Product Change Notice (PCN)

PCN Number: **PCN-0451210R-01**

Product(s) Affected: **PJ-059A**

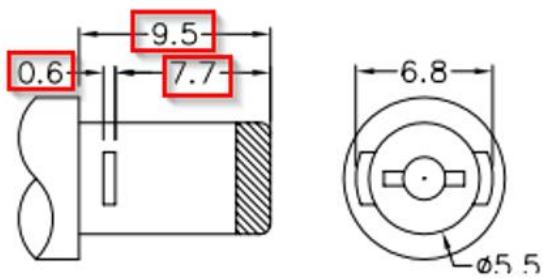
Description of Change: **Minor Housing and footprint differences. Material Change on the housing and terminals. See image Below**

PREVIOUS CUI DEVICES DETAIL / IMAGE			NEW CUI DEVICES DETAIL / IMAGE		
	MATERIAL	PLATING	DESCRIPTION	MATERIAL	PLATING/COLOR
center pin	copper	nickel	center pin	brass	nickel
terminal 1	brass	tin	terminal 1	brass t=0.30	tin
terminal 2	copper alloy	tin	terminal 2	bronze t=0.25	tin
terminal 3	brass	tin	terminal 3	brass t=0.30	tin
plastic	PBT		cover	PBT (UL94V-0)	black
			housing	PBT (UL94V-0)	black

MATING PLUG
Jack Insertion Depth: 9.8 mm

MATING PLUG
Jack Insertion Depth: 9.5 mm
